A G E N D A
JAMES CITY COUNTY DEVELOPMENT REVIEW COMMITTEE
REGULAR MEETING
Building A Large Conference Room
101 Mounts Bay Road, Williamsburg, VA 23185
March 30, 2022
4:00 PM

SITE PLAN SP- 19-0001. Powhatan Terrace

CONCEPTUAL PLAN 22-0021. 3341 Chickahominy Road Overhead Utility Waiver

SITE PLAN-20-0037. Smith Memorial Baptist Church Parking Expansion
Staff Report for the March 30, 2022, Development Review Committee Meeting

C-22-0021, 3341 Chickahominy Rd Overhead Utility Waiver

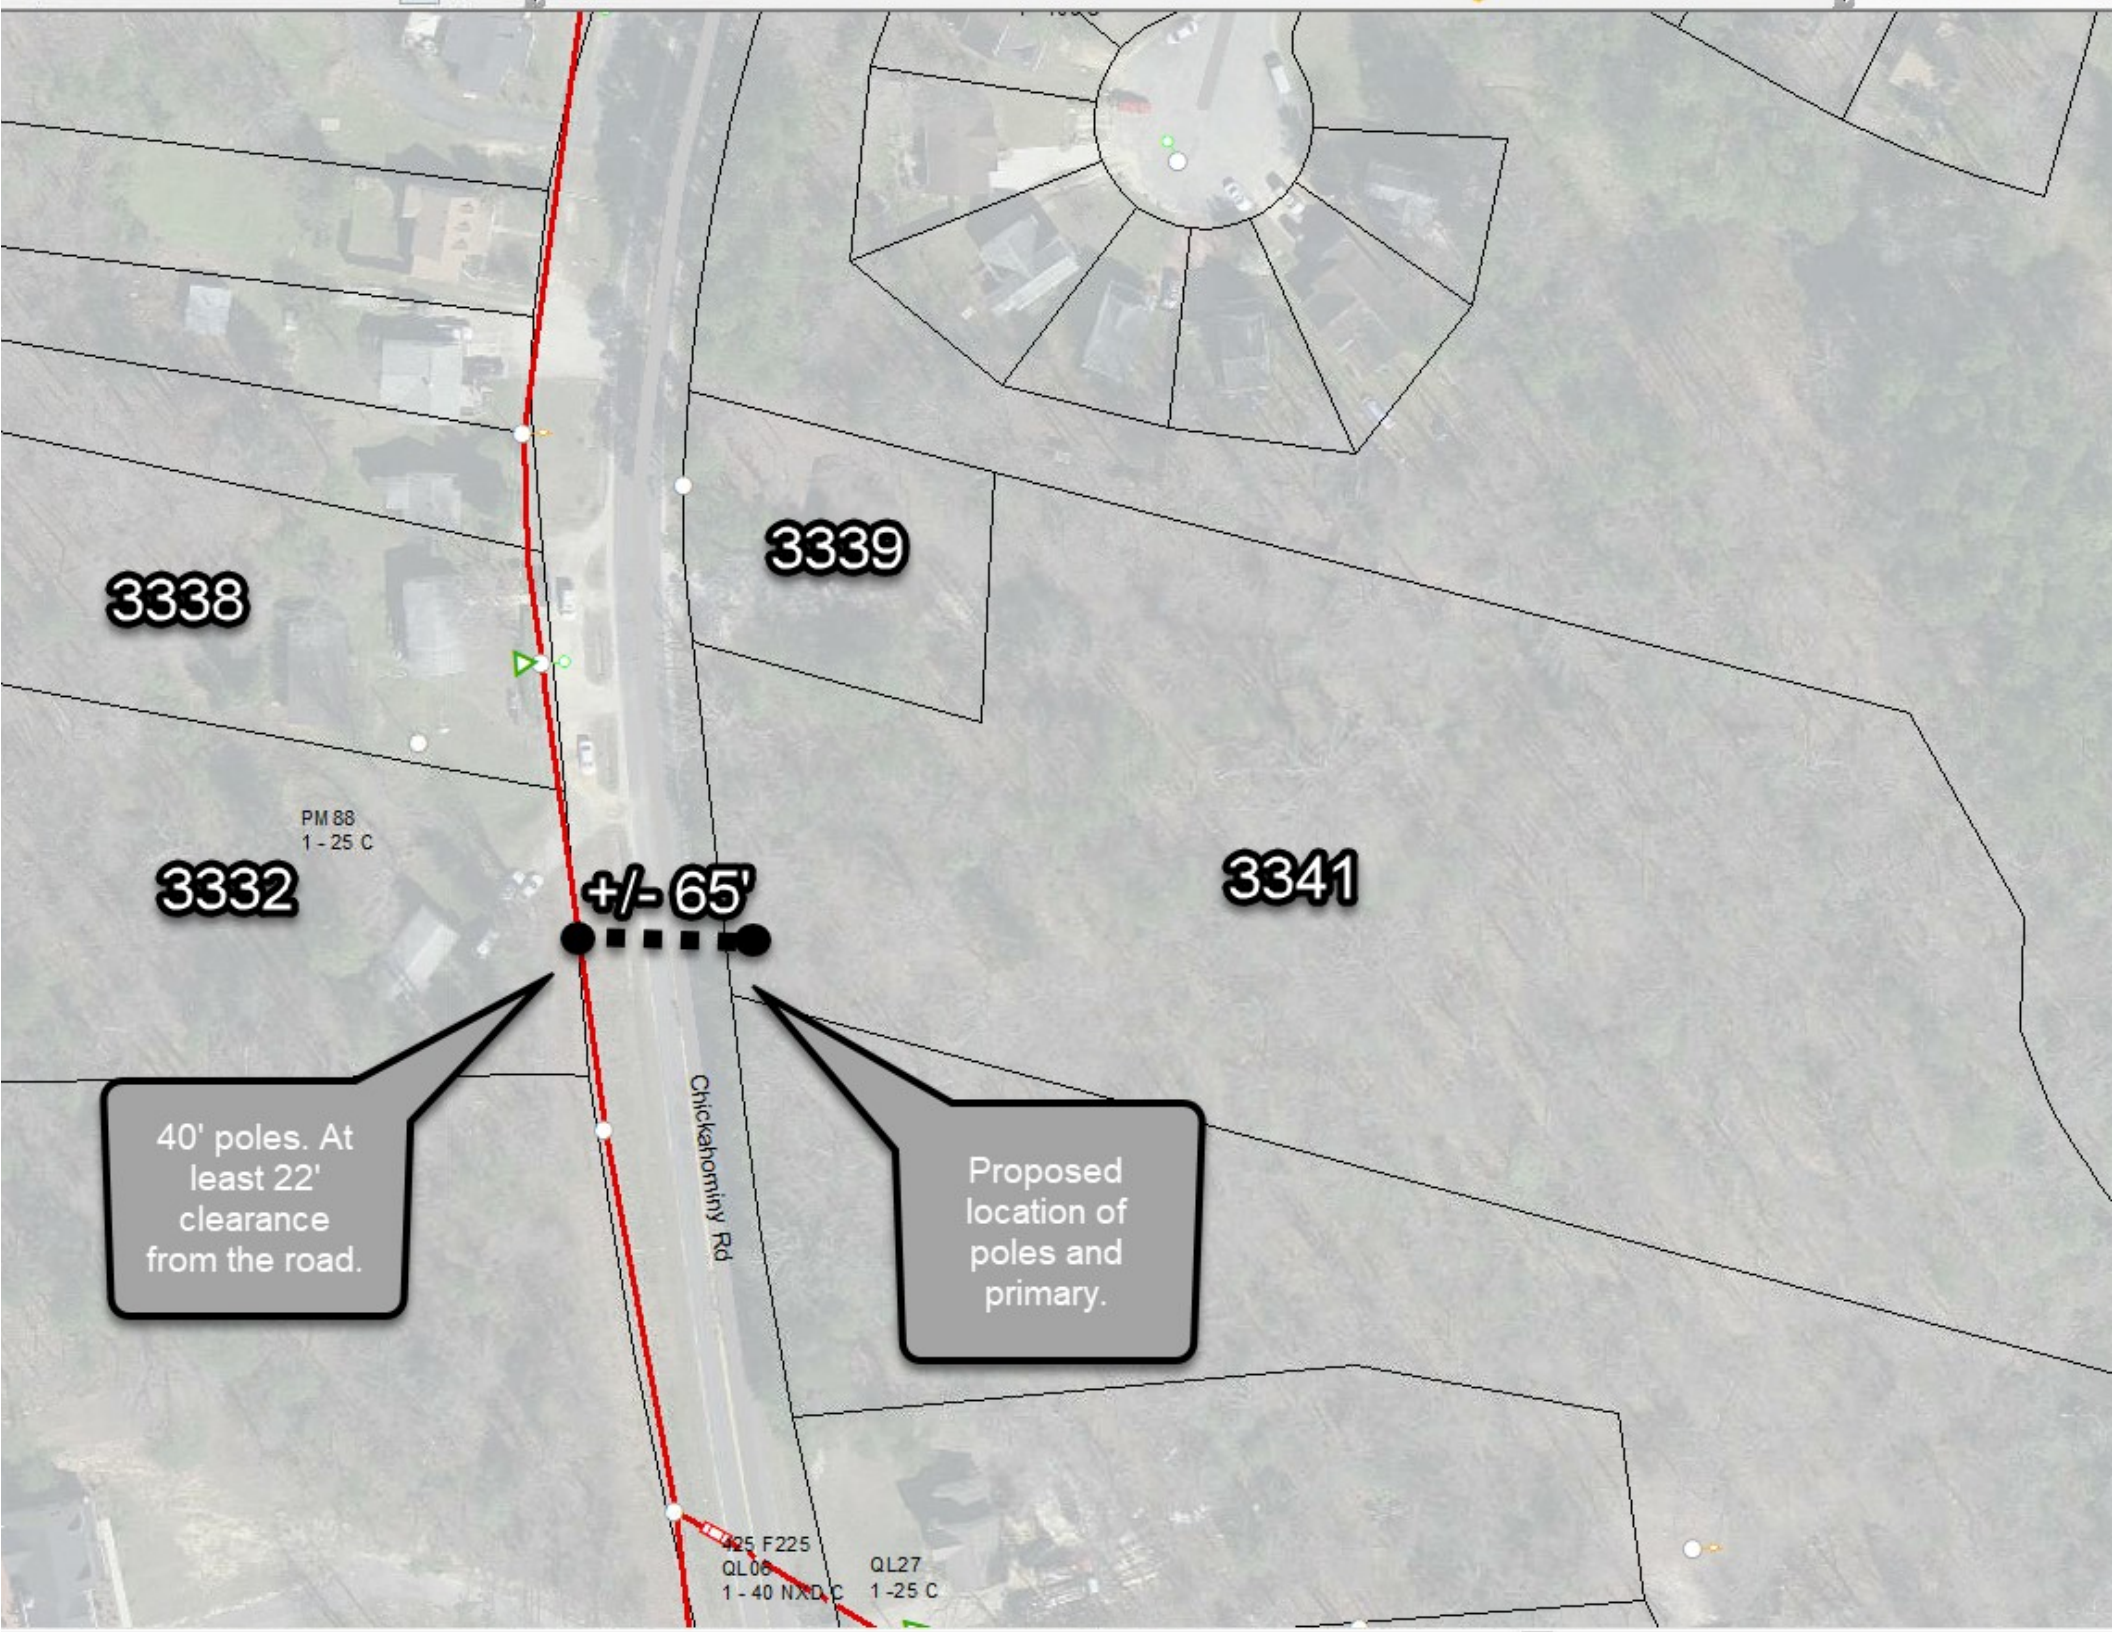
The applicant has requested a waiver to Section 24-200, Public Utilities, of the Zoning Ordinance. That section permits the Planning Commission to waive the underground utility requirement should the DRC give a favorable recommendation based upon consideration of the following circumstances, listed in Section 24-200(c): voltage requirements, existing overhead service, existing tree cover, and physical features of the site and the surrounding area.

The following factors were evaluated by staff in making its recommendation: 1) the line would be an extension of existing overhead service; 2) the property owner across the road will not grant an underground utility easement; and 3) the extension would be a short distance from existing service to the property. Due to these factors staff finds that this application meets the criteria for consideration of waiver as found in Section 24-200(c).

40' poles. At
least 22'
clearance
from the road.

Proposed
location of
poles and
primary.

Dominion will be setting a pole in line across the street at 3332 Chickahominy Road. Dominion will slack primary across the street (with no lower clearance than 22' from road per Dominion standards) and set a new pole across the street at 3341 Chickahominy Road on the right side of the driveway. Dominion will then install a terminal and underground primary to a new underground transformer. Dominion will then trench in 225' of 4/0 secondary to the meter base.
